Waterloo Metro Over Station Development, Northern Precinct (SSD-79307758) and Central Precinct (SSD-79307746)

The following memorandum is provided in response to the traffic related comments received from Transport for New South Wales (TfNSW) on 20th January 2026, which specifically relates to Northern Precinct (SSD-79307758) and Central Precinct (SSD-79307746). TfNSW did not provide any comments for the Second Amending Concept (SSD-79307765) and conditions were recommended for the Waterloo Basement Modification (SSD-10438-Mod-3), which the applicant accepts.

Figure 1 – CoS waste vehicle and MRV passing within property boundary.

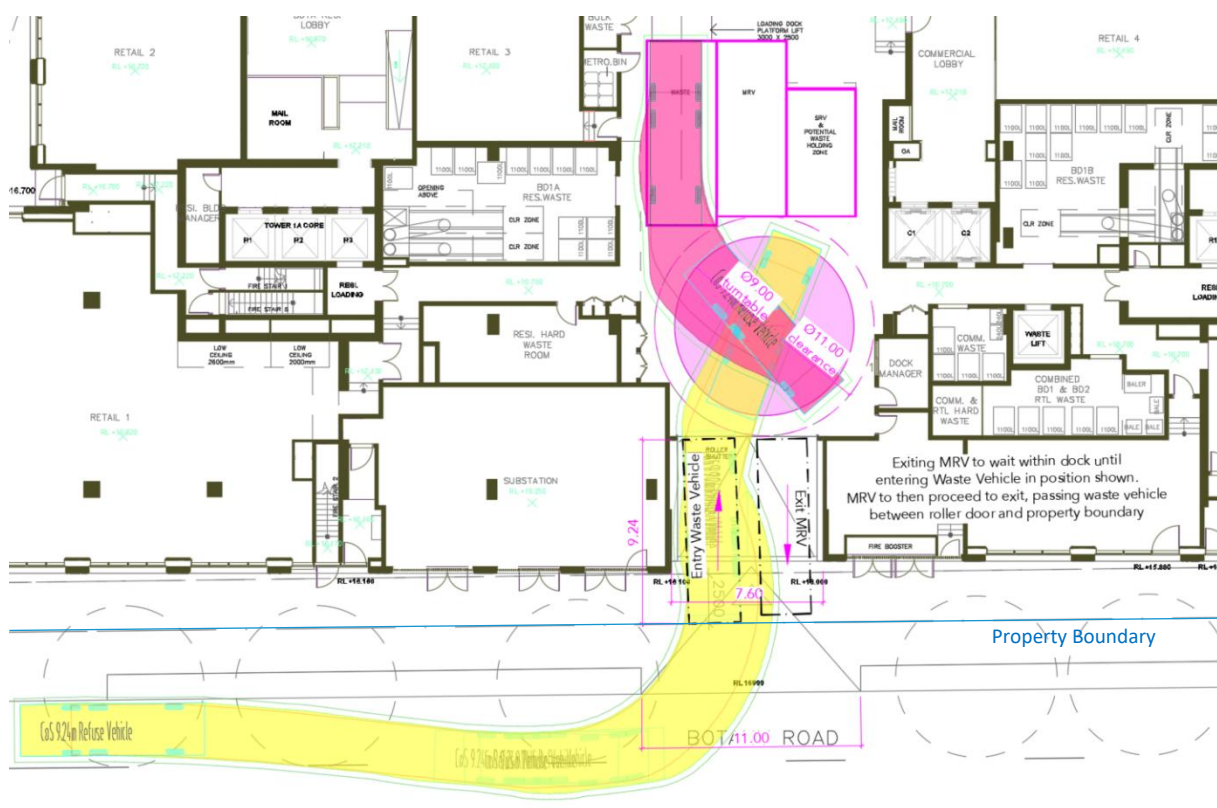
TfNSW Comment, Item 2 (a):

The available distance between the driveway, garage door, and footpath is insufficient to accommodate the longest service vehicle required to access the site. As such, service vehicles will be queued within the Botany Road road reserve (i.e. within the pedestrian/footpath area). Any queuing of service vehicles would adversely impact pedestrian movements along Botany Road and compromise the safety and efficiency of vehicular movements on Botany Road, noting the significant pedestrian movements that will result from current and planned public transport infrastructure upgrades and from this development.

The largest service vehicle required to access the site can be fully accommodated within the property boundary. The vehicle is able to enter the driveway and await access to the loading dock without encroaching on the Botany Road reserve (refer to Figure 1).

In addition, a Loading Dock Management Plan (LDMP) will be implemented to manage operational protocols for the loading dock. The LDMP will include staggered and scheduled use of the loading dock to avoid entry and exit conflicts as well as procedures to ensure effective coordination between service providers and the loading dock manager.

Figure 2 – Visibility Splays

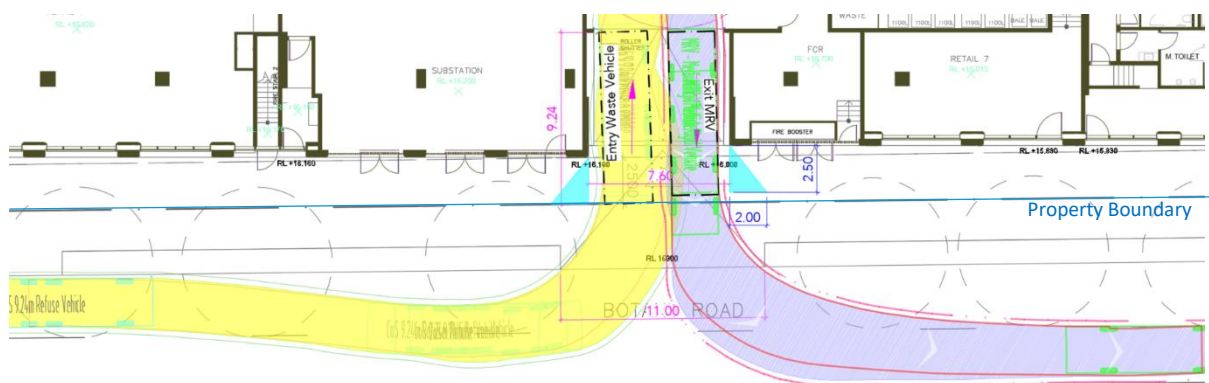
TfNSW Comment, Item 2 (b):

Pedestrian sight distances at the Botany Road access are constrained by the building being located on the property boundary. Given the site's location above Waterloo Metro Station and the expected high pedestrian volumes, vehicle access arrangements must provide adequate sight lines to pedestrians and cyclists.

The building is set back from the property boundary at the Botany Road access point, ensuring that the required pedestrian sight lines are achieved. As a result, there is no visibility obstruction to the public footpath, and the arrangement complies with the sight distance requirements prescribed in AS2890.2 – Figure 3.4 (refer to Figure 2).

In addition to meeting the relevant standard, several operational and physical measures will further enhance visibility and pedestrian safety. Standard exit signage will be installed instructing drivers to “STOP – GIVE WAY TO PEDESTRIANS,” reinforcing pedestrian priority at the interface with the footpath. A convex mirror can also be installed on the northern wall of the entryway to improve intervisibility between exiting vehicles and approaching pedestrians or cyclists.
